CHANGE NOTICE

Date: 2-16-16

Component Product Title: Series XXI Pedestal

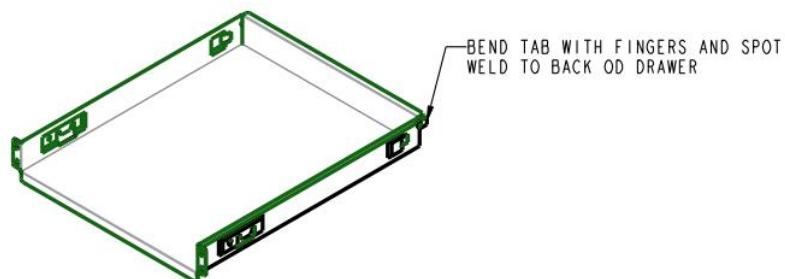
The Series XXI Pedestal Pencil Drawer Bodies have been changed and updated to a one-piece formed unit. The old part numbers are as follows:

- 2.KP40220 – 20” Pencil Drawer Body
- 2.KP40221 – 24” Pencil Drawer Body
- 2.KP40222 – 30” Pencil Drawer Body

- 2.KP40195.20 – 20” Pencil Drawer Body
- 2.KP40195.24 – 24” Pencil Drawer Body
- 2.KP40195.30 – 30” Pencil Drawer Body

The reason for the change is to improve drawer body construction and to improve factory through-put.

Please update the Pedestal Pencil Drawer body part numbers to reflect the new drawer bodies.
